C. Building Permit Rejected Planning Board - Site Plan Review									
Reason For Rejection:	B-21-2317								
SEE ATTAChments"	D 21 2017								
Comments and Conditions:									
0									
Signed Namuel Date:	5 20 2/								
Title Bulding (ommits 10ther									
that valid unless signed (not stamped) by Building Commissioner

New Bedford Comprehensive Zoning Code Review Code of Ordinances – Chapter-9

1250-1260 Shawmut Avenue - PLOT: 123 - LOT: 106 - ZONED DISTRICT: IA

FOR SOLAR CANOPY

SC101

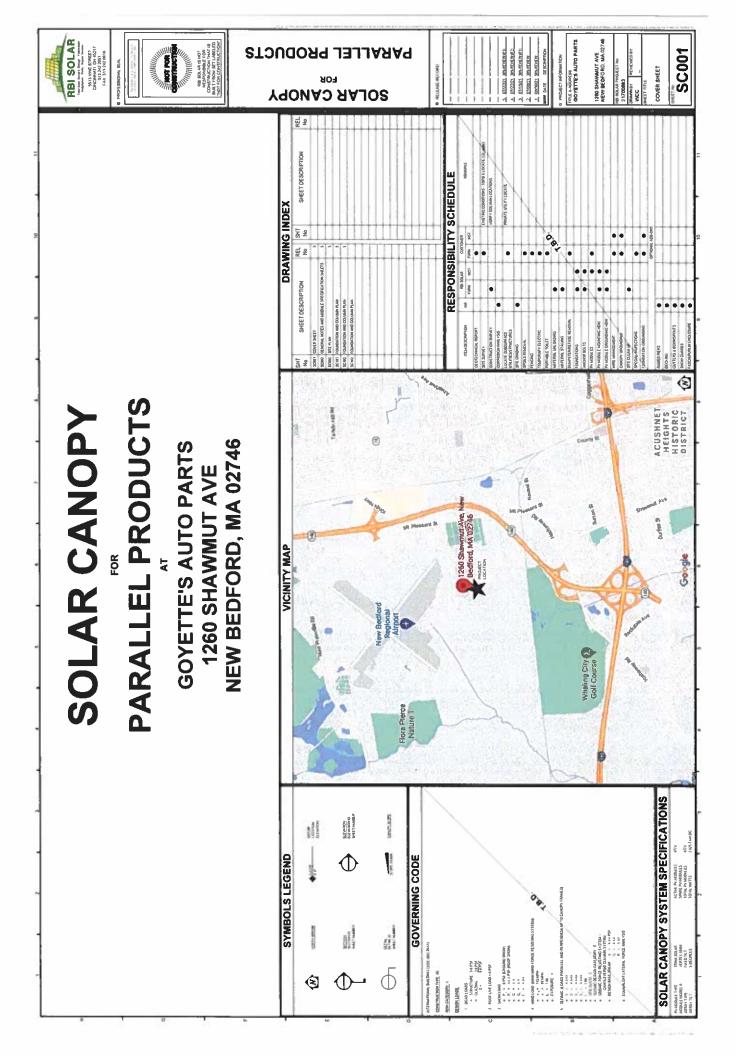
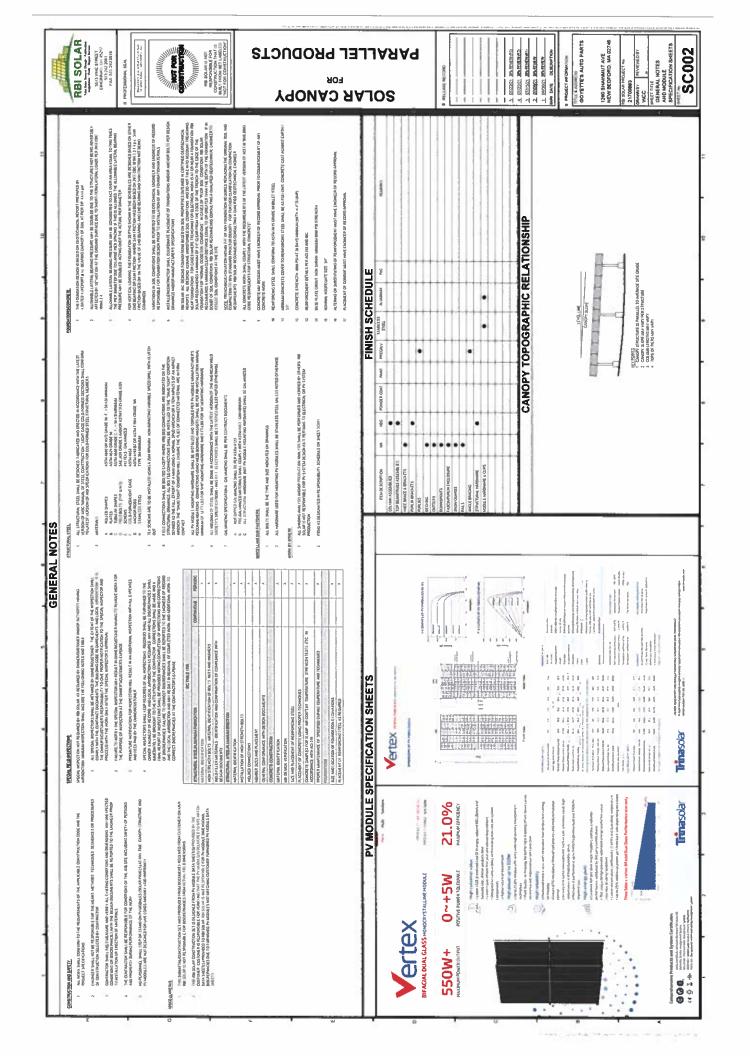
- Conservation Commission The applicant will need to file a Notice of Intent
- <u>Fire Department</u> The applicant is to ensure there is proper access and turn radius for fire apparatus. Also have a main shut off at front of entrance.
- <u>Airport</u> In order for the Airport to make a decision on this permit application we will need to have a copy of the Airspace Review done by the FAA and MassDot Aeronautics.
- <u>Setback</u> No setback provided for this project therefore all setbacks must adhere to the minimum 25ft setback.

We are about 99% complete with the rejection, the only thing we need is actual is a site plan from you, showing that the new carports are not within the 25ft setback for the industrial area. Please get back to me you can.
